Addendum No.1

Project: Audie Murphy Hospital - Replace HVAC Units - Phase IV

Issuance Date: June 13, 2014

Item No. 7 Sheet E-105 - ELECTRICAL ONE-LINE DIAGRAM

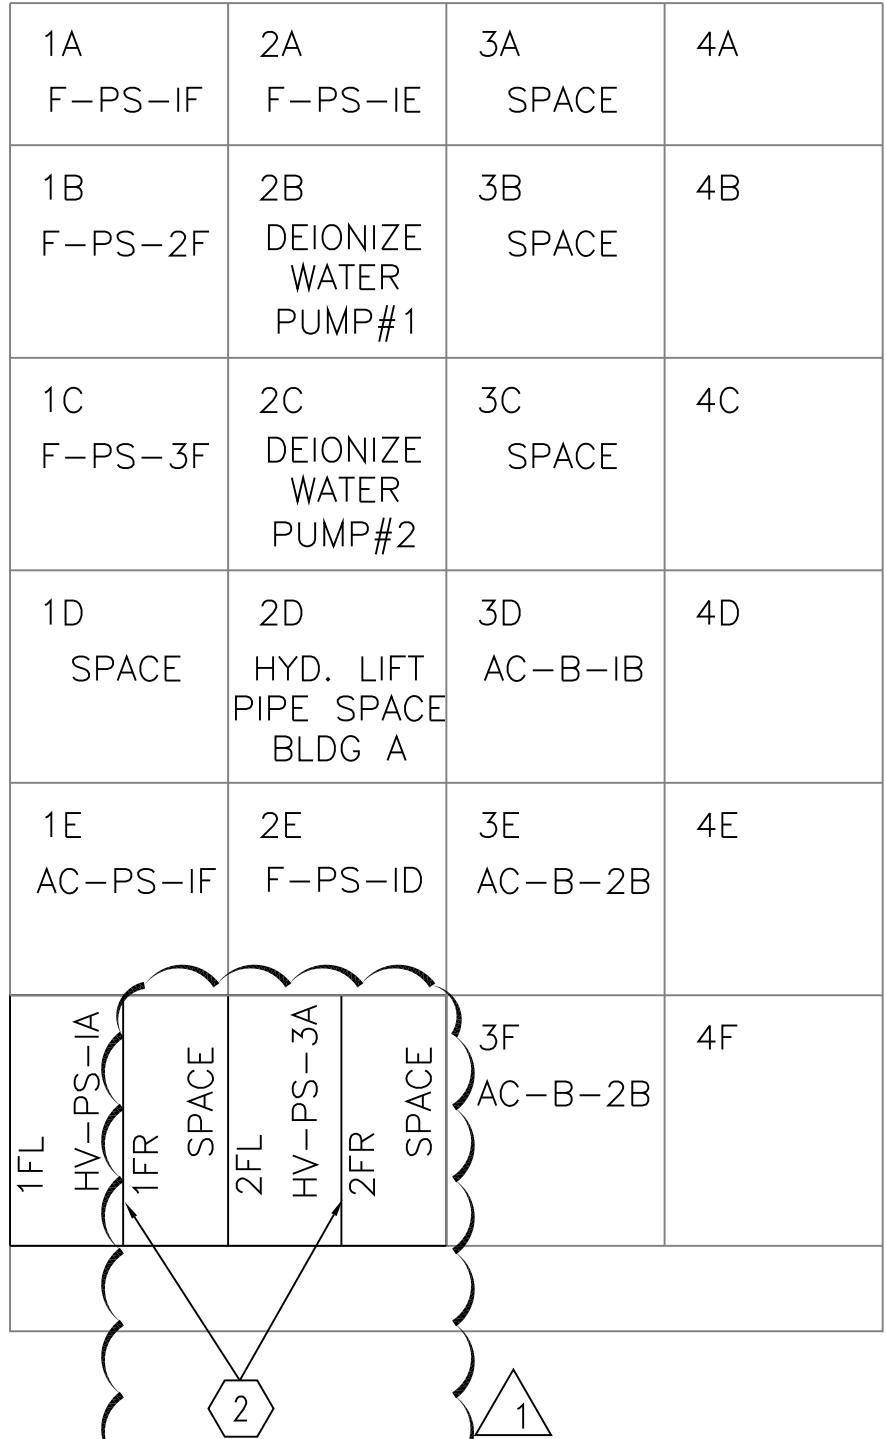
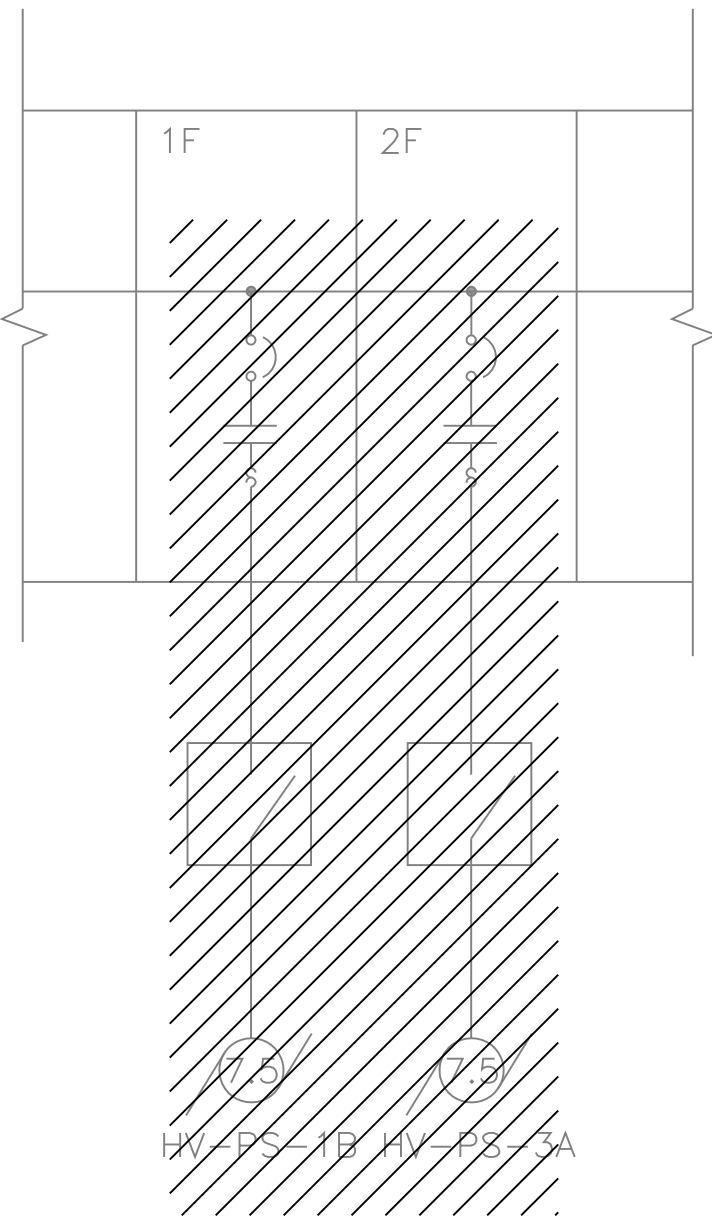
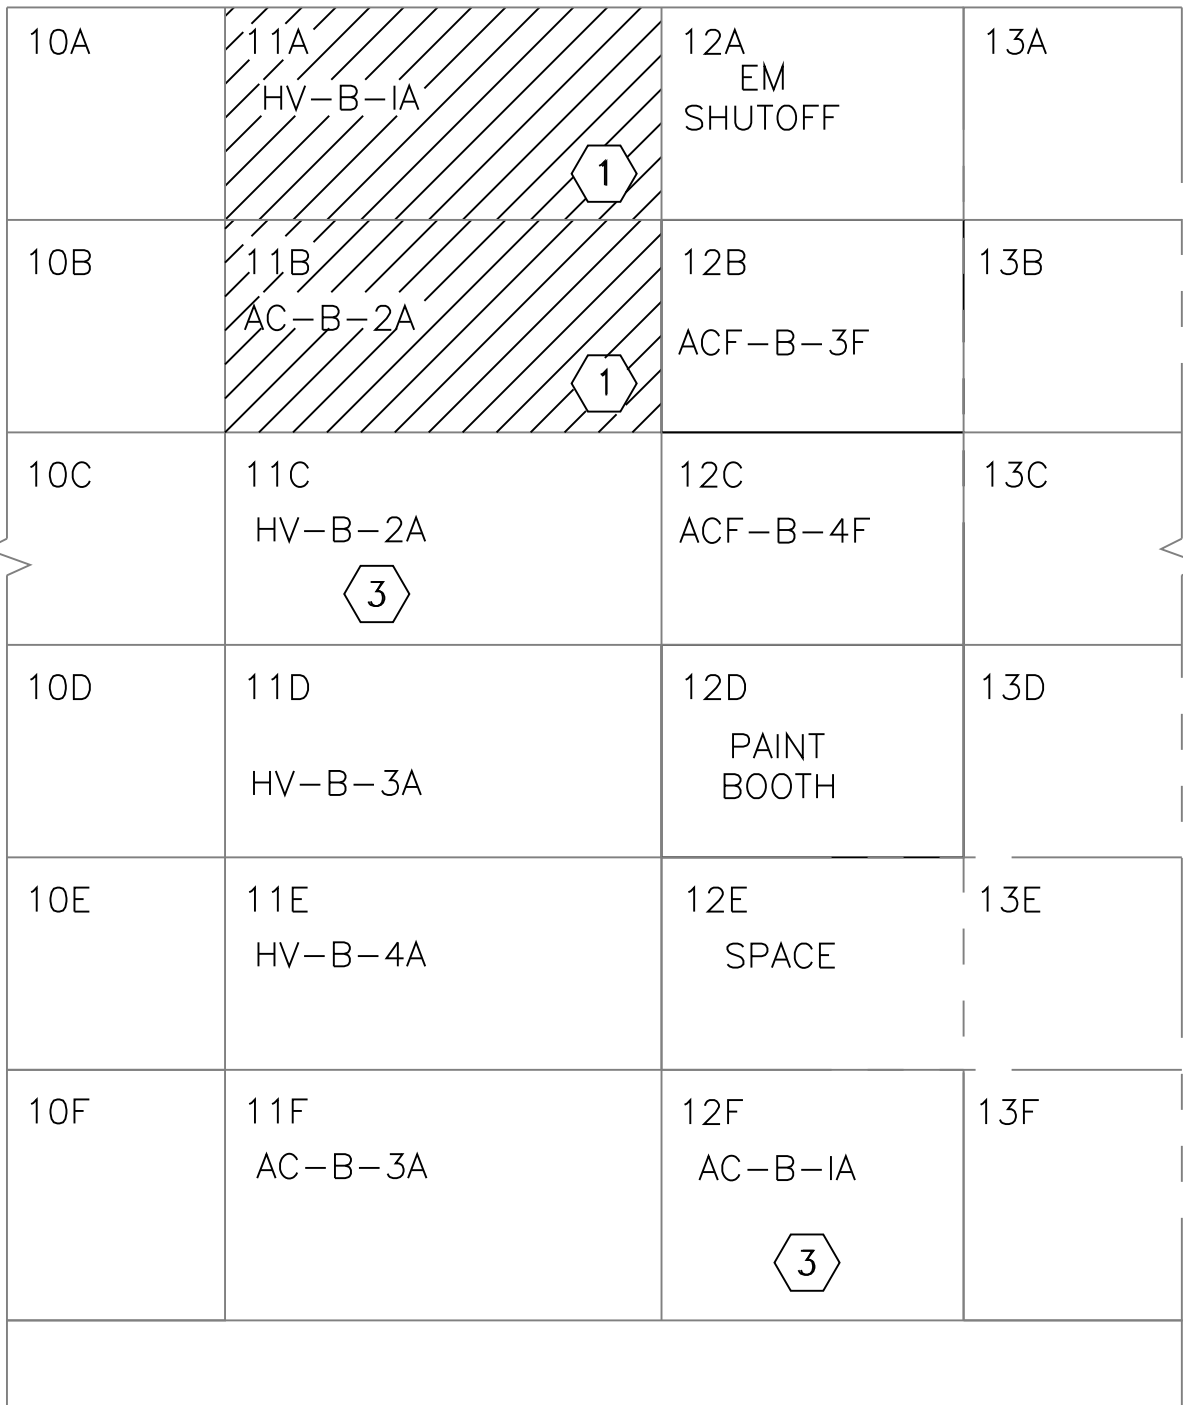
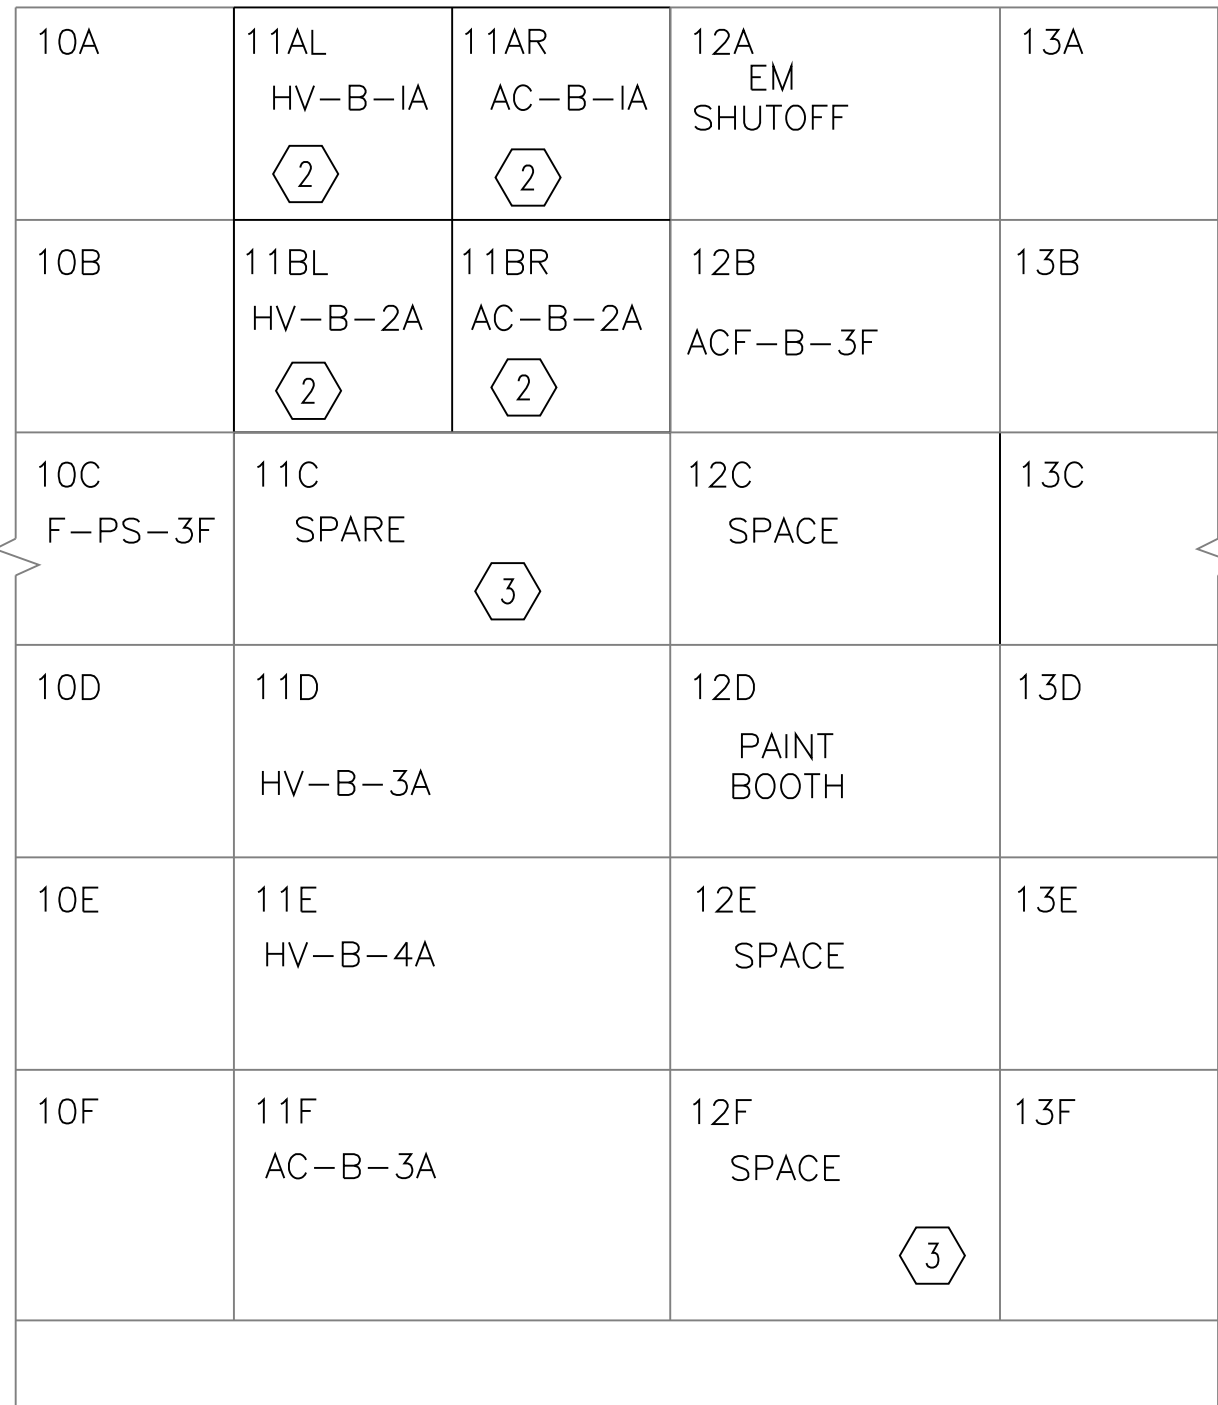
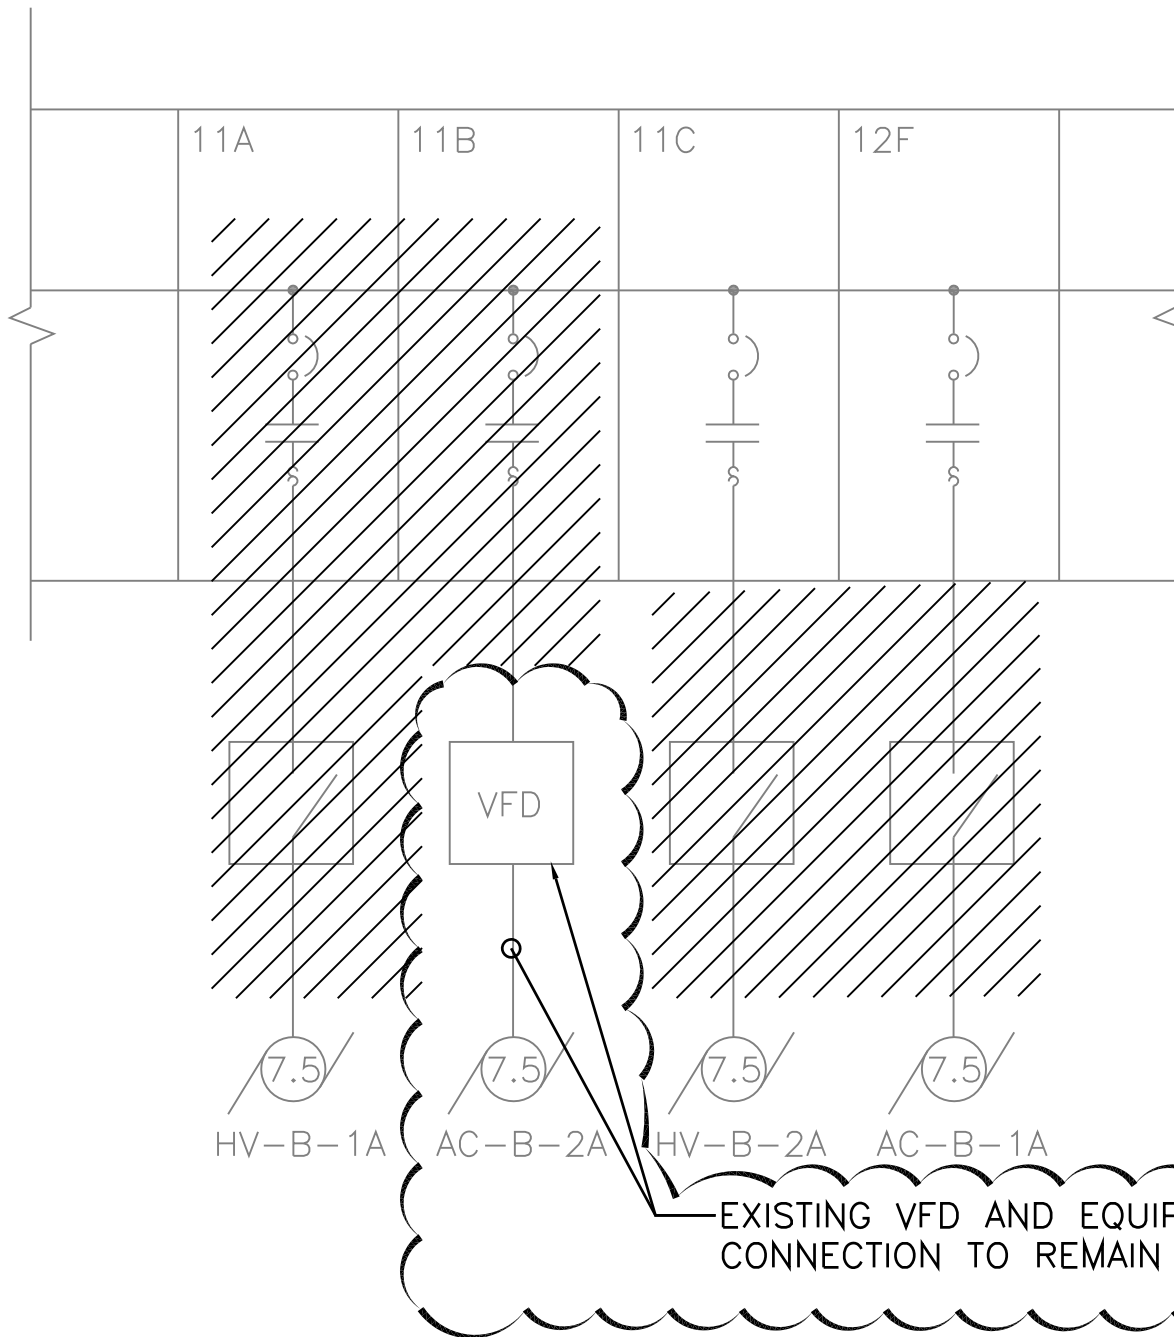
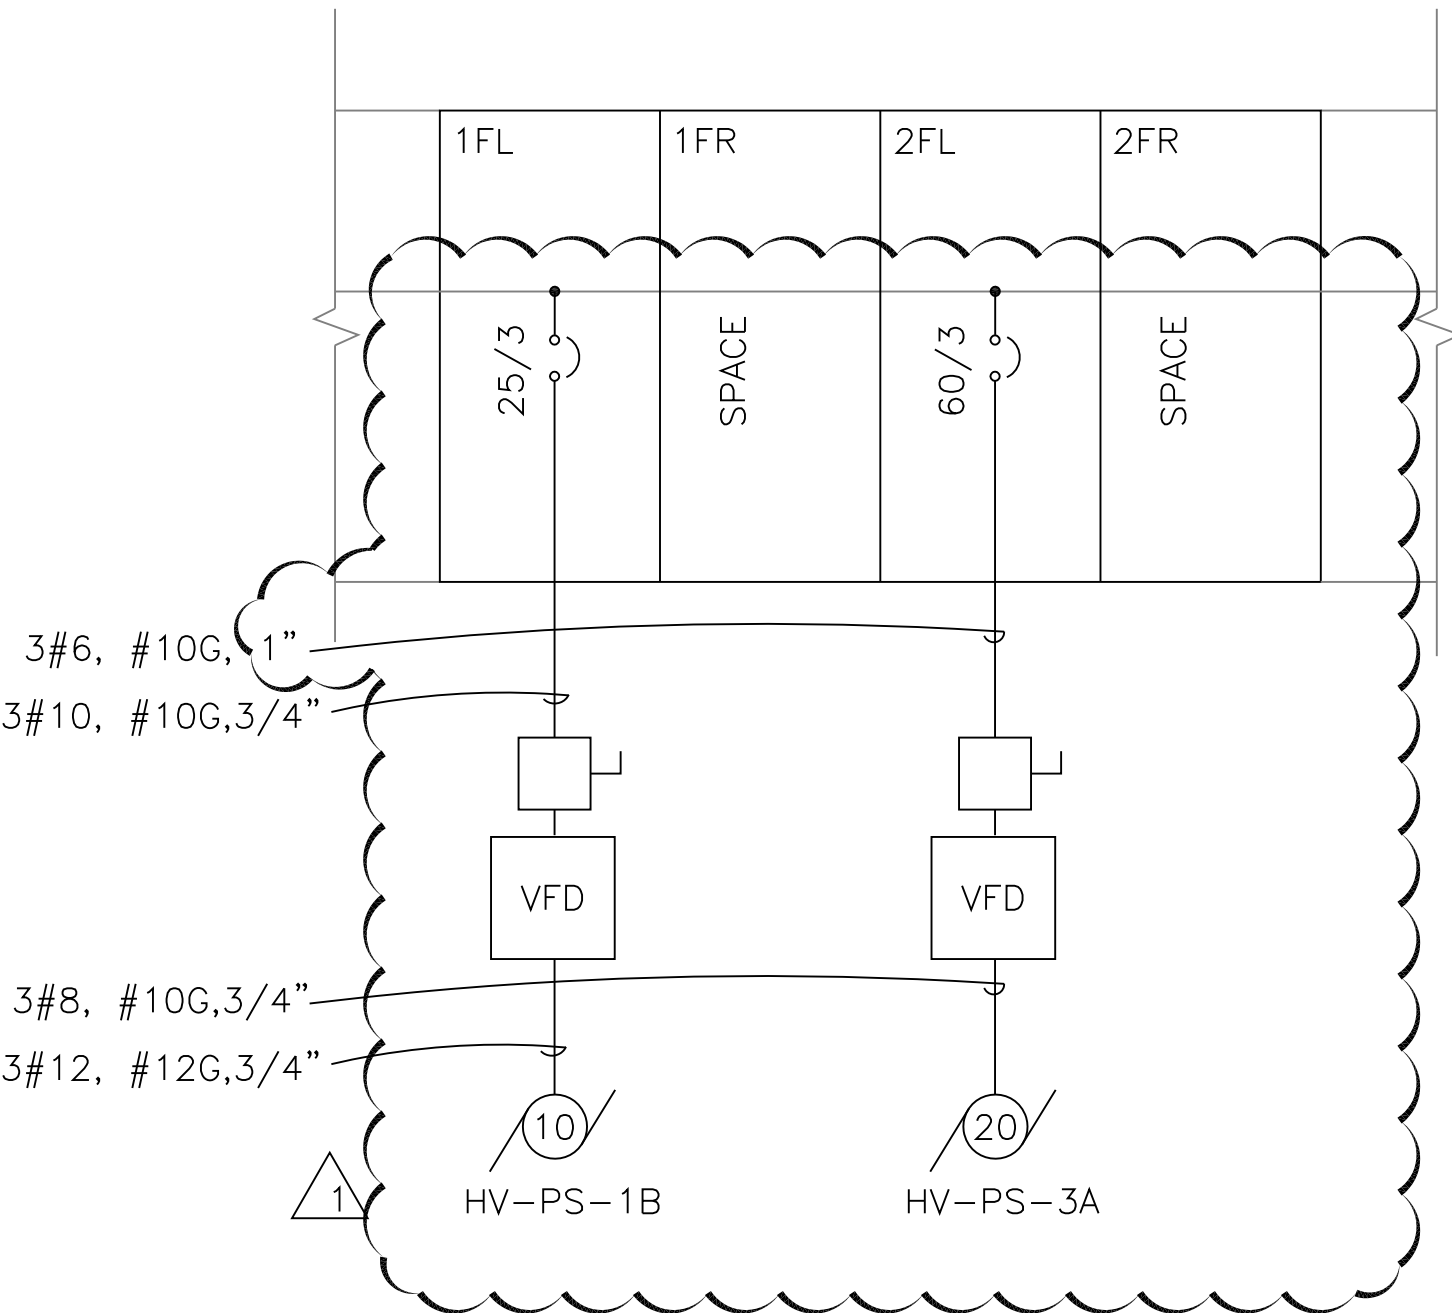
1. The Contractor shall furnish and install electrical gear, circuits, etc. as shown on the attached drawing.
